[Docket No. 2002–SW–15–AD; Amendment 39–12817; AD 2002–14–17]

Airworthiness Directives; Eurocopter Deutschland GmbH Model EC135 Helicopters

ACTION: Final rule; request for comments.

Crack inspection on main rotor hub-shaft
Figure 1

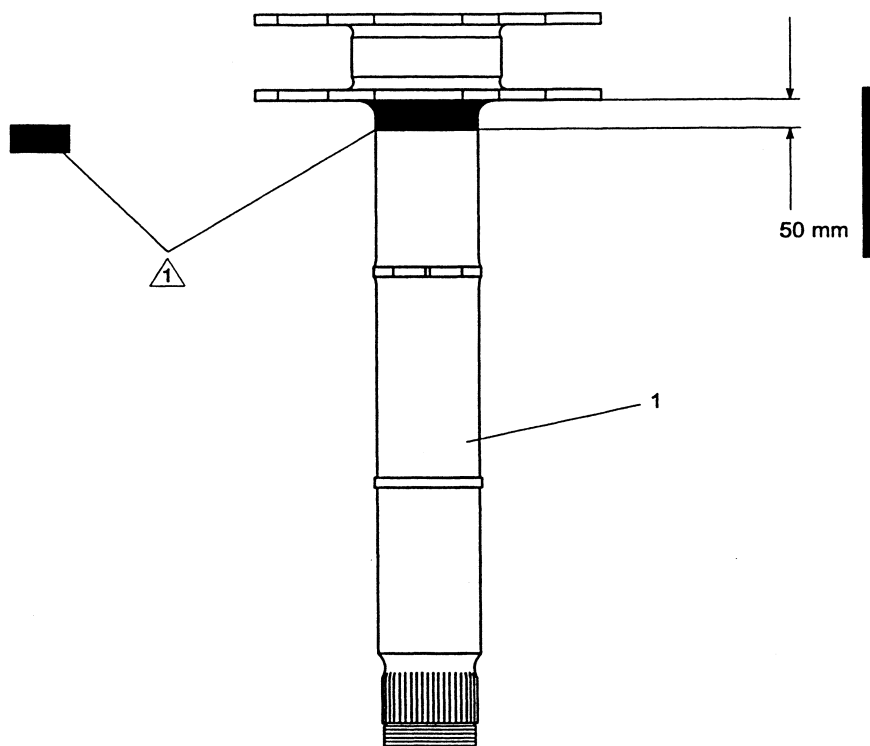
SUMMARY: This amendment supersedes an existing airworthiness directive (AD), applicable to Eurocopter Deutschland GmbH (ECD) (Eurocopter) Model EC135 helicopters, that currently requires initial and repetitive visual inspections and a one-time dye-penetrant inspection of a certain main rotor hub shaft (shaft) for cracks, and replacement of any cracked shafts. This amendment requires the same actions as the existing AD, but corrects the shaft part number (P/N) in the current AD, includes additional P/N's, increases the area of inspection from a 40mm area to a 50mm area of the shaft, and provides an option

The FAA has determined that AD 99–12–01 contained an error in the applicable shaft P/N–P/N L623M100S 101 should have been stated as P/N L623M1003 101. Also, the FAA has determined that additional shaft P/N's should have been included in the AD and that operators should have an option with regard to the repetitive inspections of either conducting a visual inspection at intervals not to exceed 15 hours time-in-service (TIS) or a dye-penetrant inspection at intervals not to exceed 100 hours TIS.

(a) Before further flight, clean and visually inspect the shaft for cracks in the area as shown in the following Figure 1:

(b) Within 10 hours time-in-service (TIS) after accomplishing the visual inspection required by paragraph (a) of this AD, clean and dye-penetrant inspect the shaft for cracks in the area as shown in Figure 1 of this AD.

△ 1 Inspect marked area i.a.w. crack inspection procedure described.

(c) Thereafter, visually inspect the shaft for cracks in accordance with paragraph (a) of this AD at intervals not to exceed 15 hours TIS, or dye-penetrant inspect the shaft for cracks in accordance with paragraph (b) of this AD at intervals not to exceed 100 hours TIS.

(d) If a crack is discovered during any shaft inspections, remove the shaft and replace it with an airworthy shaft.
